Re: Amendment for SES-LIC-20210729-01285; Callsign E210298; Elbert, CO

This letter is to provide detail for an amendment to SES-LIC-20210729-01285, the license application for the Starlink earth station in Elbert, CO. This letter is also a response to requests from the Federal Communication Commission to provide supplemental information with regard to this earth station application.

Figure 1: PFD Contour with county boundaries

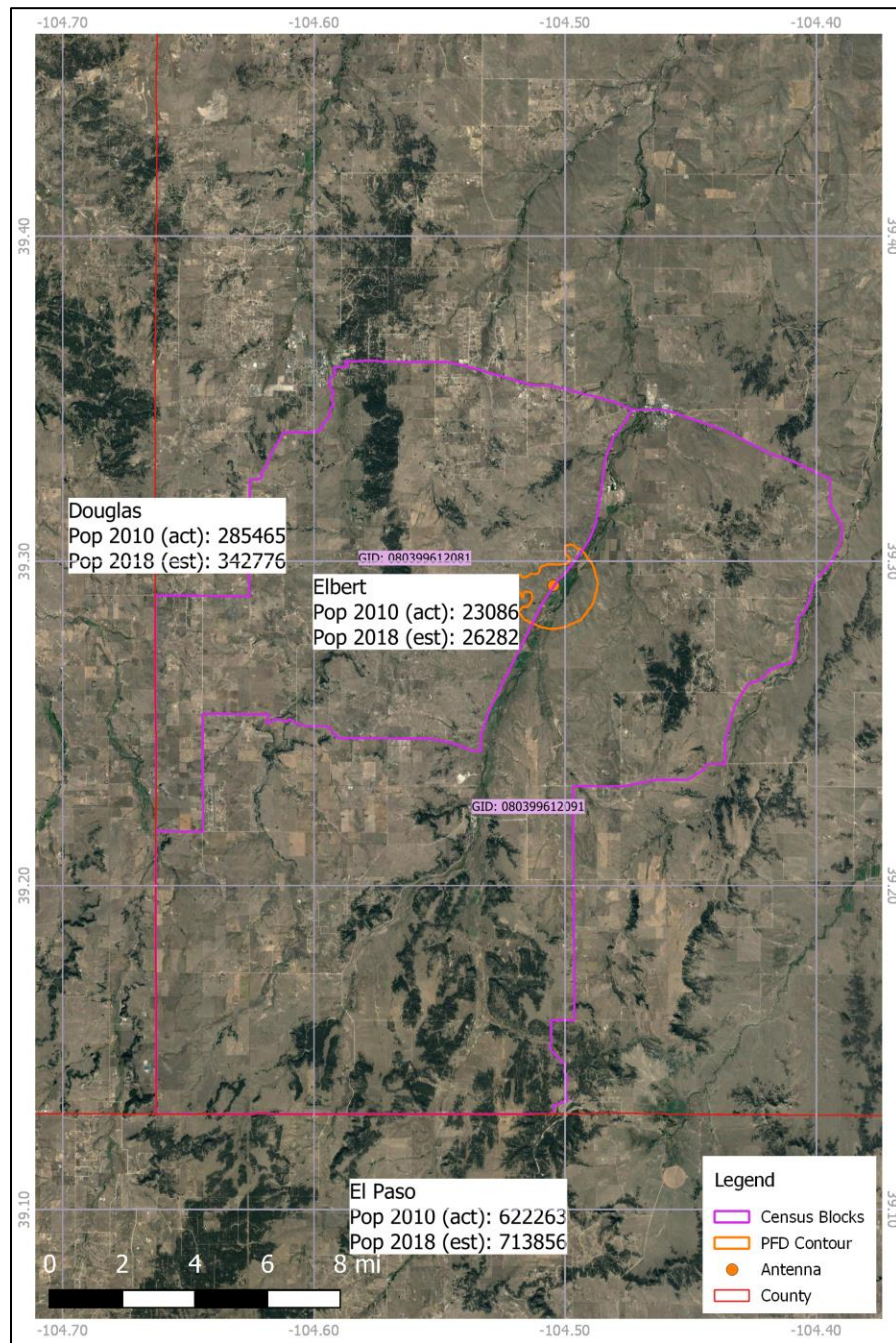
In accordance with 47 CFR § 25.136(a)(4)(ii), county boundaries and map legends with distance/mileage scale for measuring the relative size of the proposed PFD contour are included as Figures 1-3 in the appendix of this document.

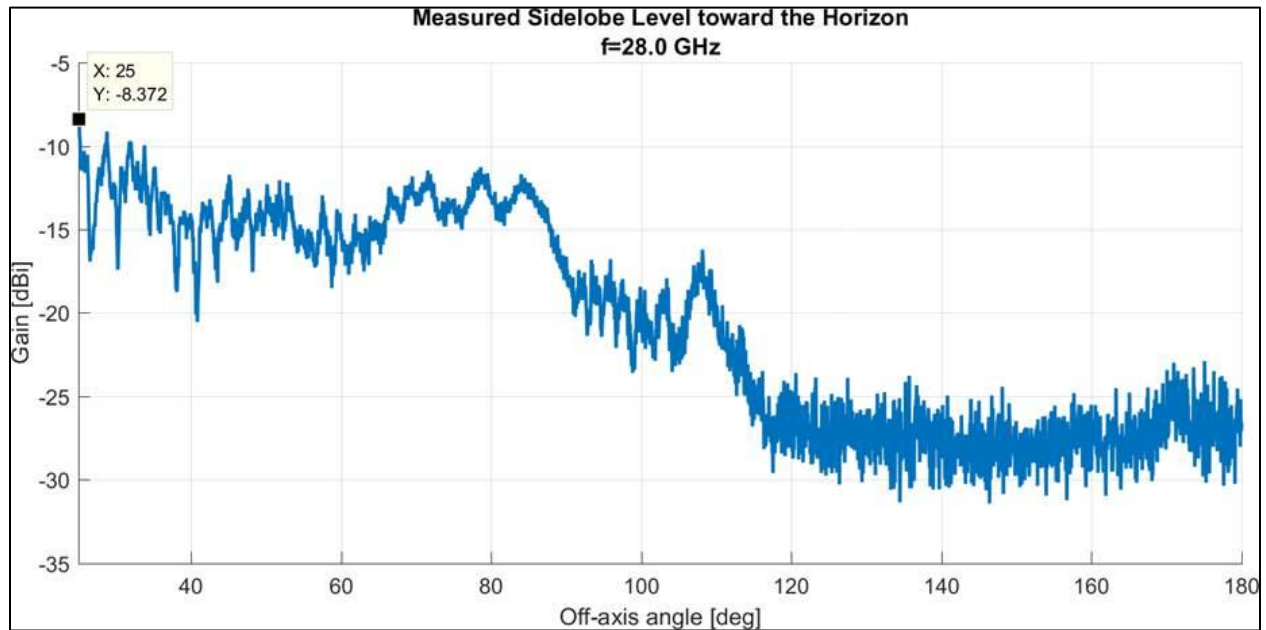
The antenna sidelobe level toward the horizon used in the license application for this gateway is -8 dBi. Previous applications for other gateway sites may have featured a different value for the antenna sidelobe level toward the horizon. This difference is due to improvements in SpaceX gateway antenna design over time – newer antennas have a lower antenna sidelobe level toward the horizon. See appendix Figure 4 for detail on antenna sidelobe measurements and related methodology.
